APP/EPR/659

**APPEAL BY THAMES WATER UTILITIES LTD  
ENVIRONMENTAL PERMITTING (ENGLAND AND WALES) REGULATIONS 2016  
READING SLUDGE TREATMENT WORKS, ISLAND ROAD, READING RG2 0RP  
ENVIRONMENT AGENCY STATEMENT OF CASE  
DATE: 14/03/2024**

Source: 'STC IED Containment Options report', dated May 2023 'Figure 4.1 – Containment Option 1 – Wide area containment option.

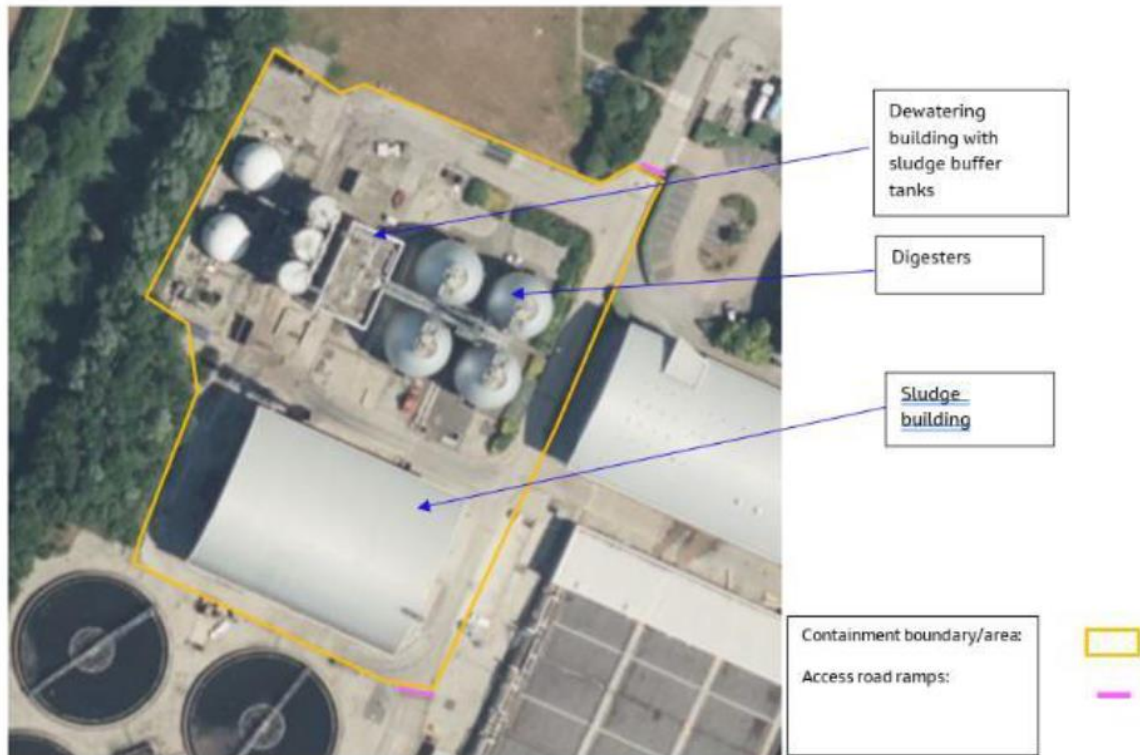
- A proposal for an outline secondary containment design based on 25% of the total tank volume plus rainfall as outlined in CIRIA C736. This identified the need to contain a volume of 2,915m<sup>3</sup> of the total tank volume. This solution included a preferred containment option, identified as *“option 1 – wide containment approach as outlined in section 4.1.1, to construct a 350m long bund wall (500 - 1000mm high) around the wide containment area. Containment ramps will be constructed across the road crossings. Tertiary containment to be provide by the existing site wide boundary bund and installation of a 250mm high ramp across the main site access road 12m length. In addition to the containment elements, isolation of the site drainage system linked to the containment area will be required to mitigate the risk of unmanaged flows impacting the sewage treatment works. Existing gravelled and grass areas within the containment will be replaced with concrete. Elements of the site roads will be replaced/repared to allow them to present an impermeable surface.”* This approach would satisfy the basic requirements of BAT 19d which requires, *“techniques to reduce the likelihood and impact of overflows and failures from tanks and vessels”* and *“tanks for liquids that are located in a suitable secondary containment; the volume is normally sized to accommodate the loss of containment of the largest tank within the secondary containment”*.
